ADDENDUM NUMBER TWO

**RE: Renovations to University Presbyterian Church
Baton Rouge, LA
Architect's Project Number: 10008**

PORTE COCHERE ROOF AND COVERED ENTRY ROOF FRAMING - PLAN VIEW

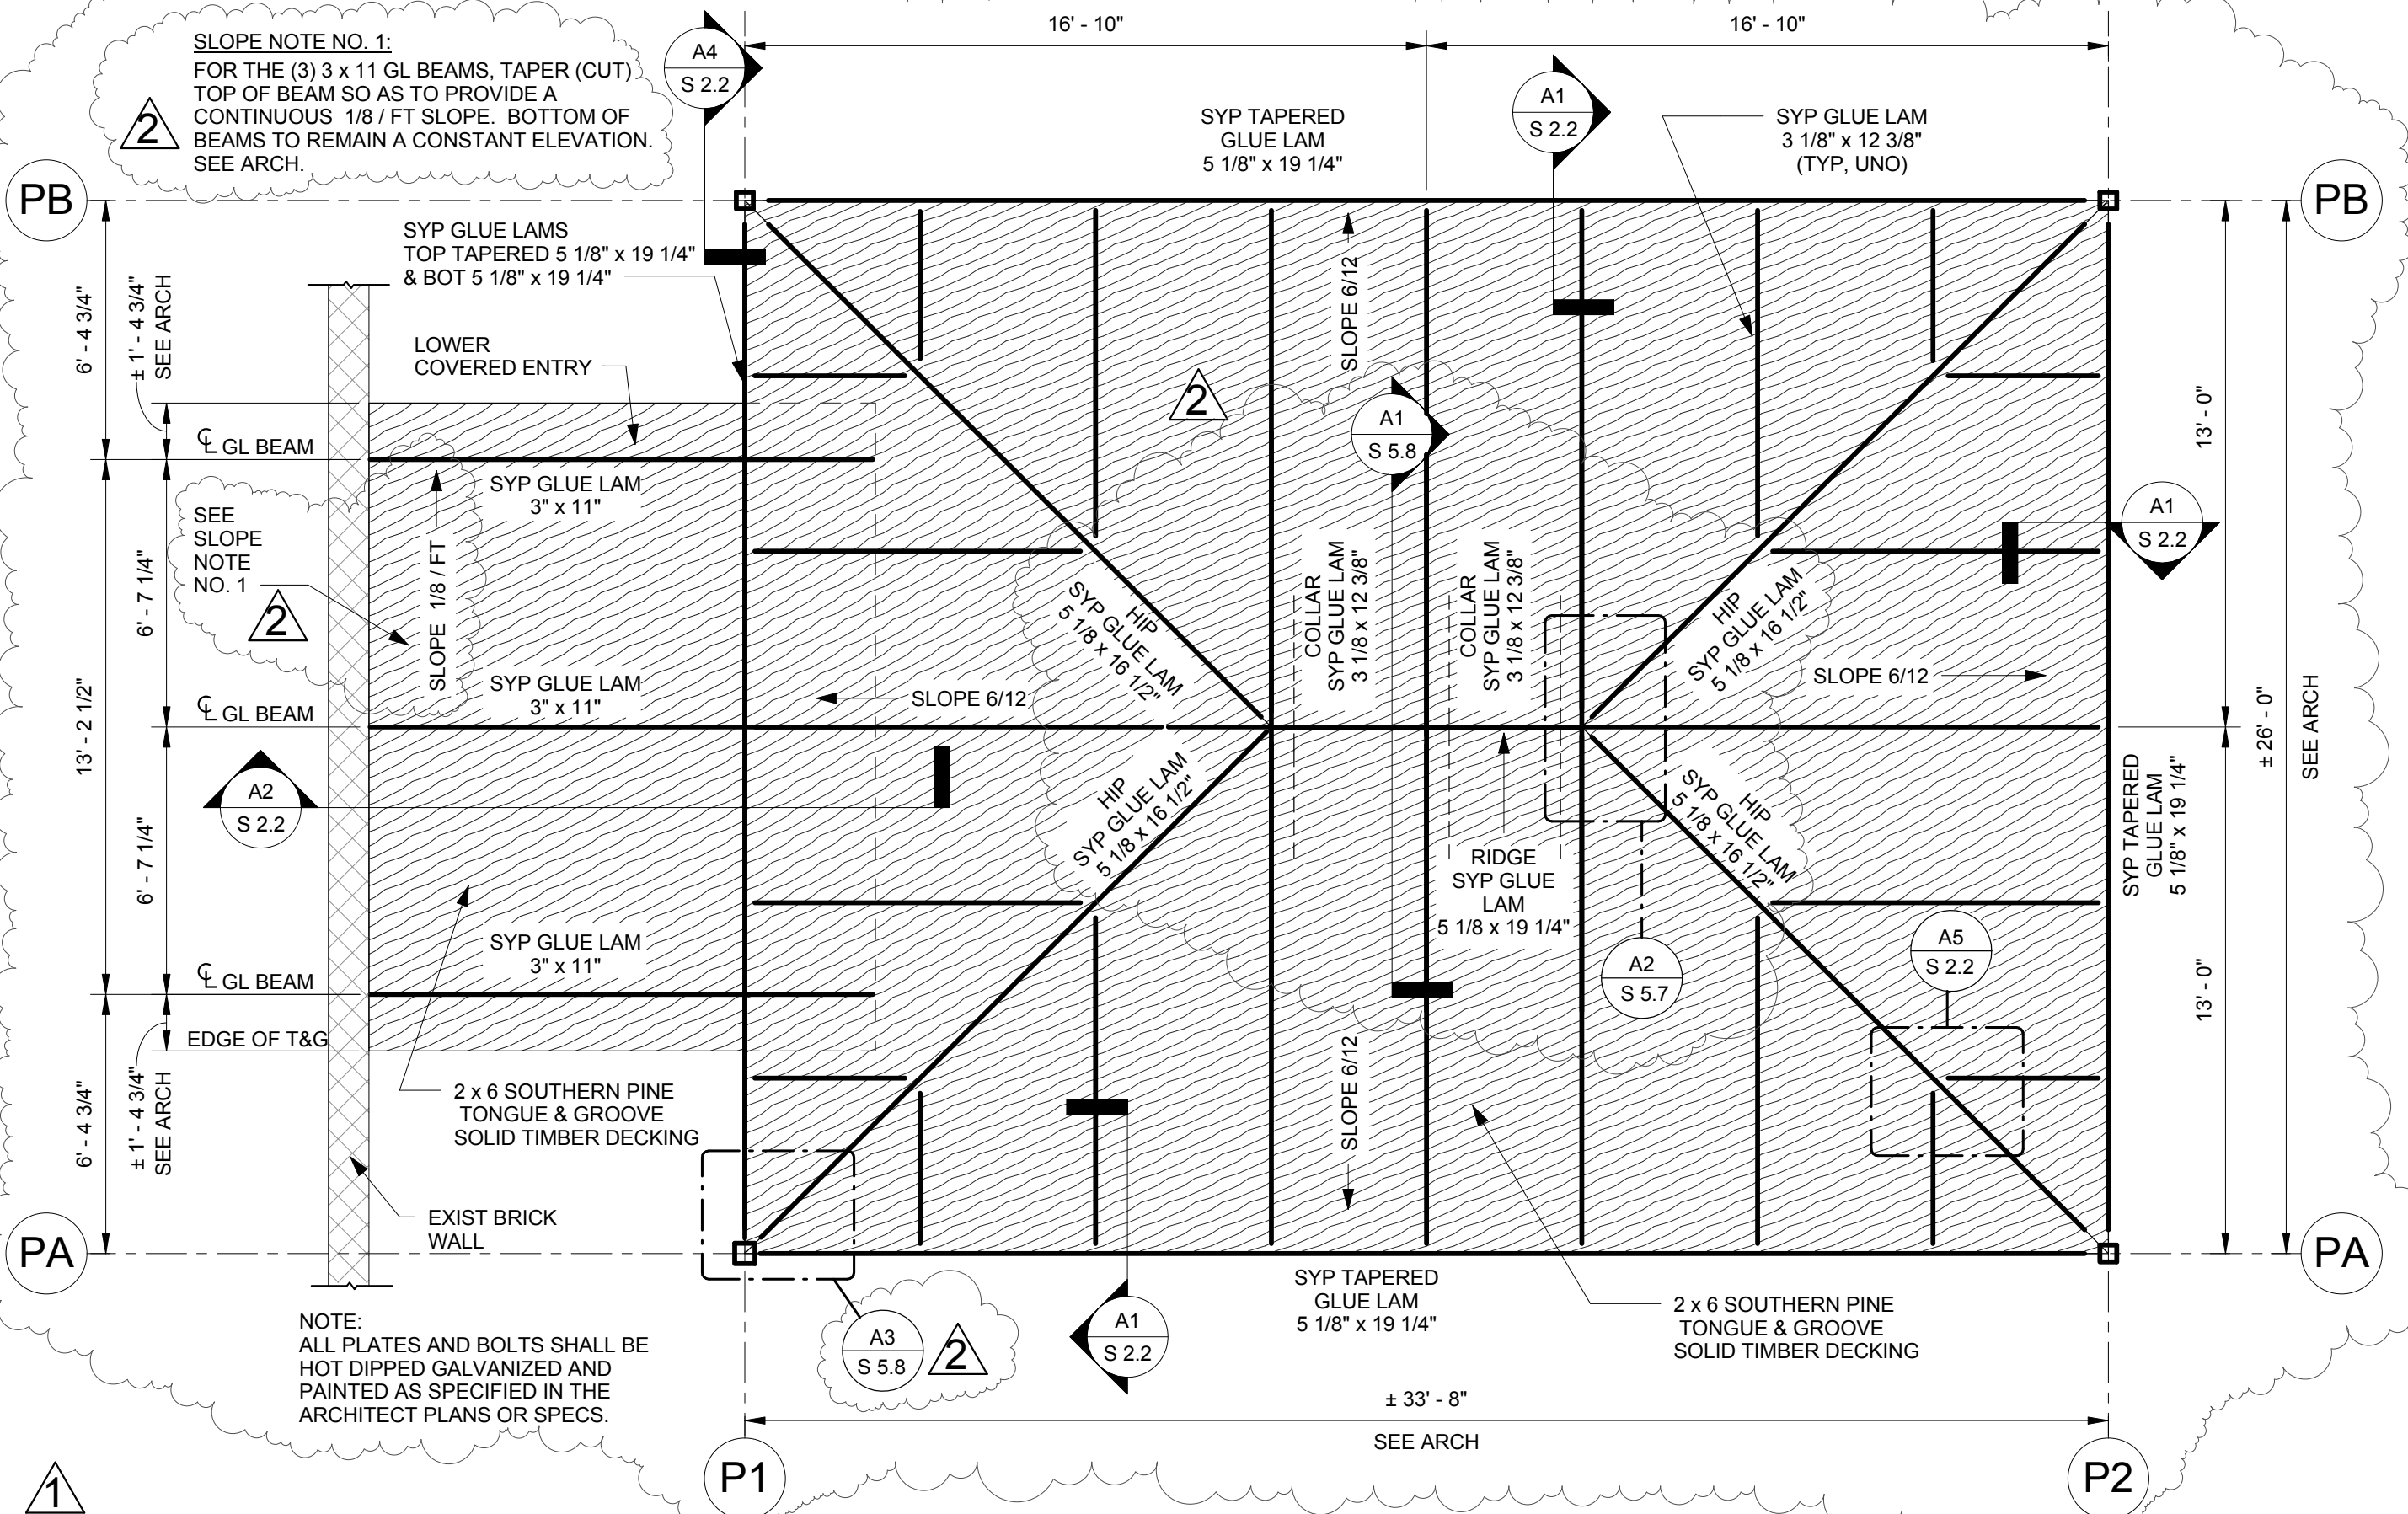
- a) (1) 11"x17" NEW sheet S5.7 for revisions to Sheet S2.2 "Porte Cochere Roof and Covered Entry Roof Framing" dated 09.30.11 with revisions clouded.
- b) (1) Full Size NEW sheet S5.7 "Addendum" dated 09.30.11 with revisions clouded for additional framing details on the Porte Cochere Roof and Covered Entry Roof.

SLOPE NOTE NO. 1:
FOR THE (3) 3 x 11 GL BEAMS, TAPER (CUT) TOP OF BEAM SO AS TO PROVIDE A CONTINUOUS 1/8' / FT SLOPE. BOTTOM OF BEAMS TO REMAIN A CONSTANT ELEVATION. SEE ARCH.
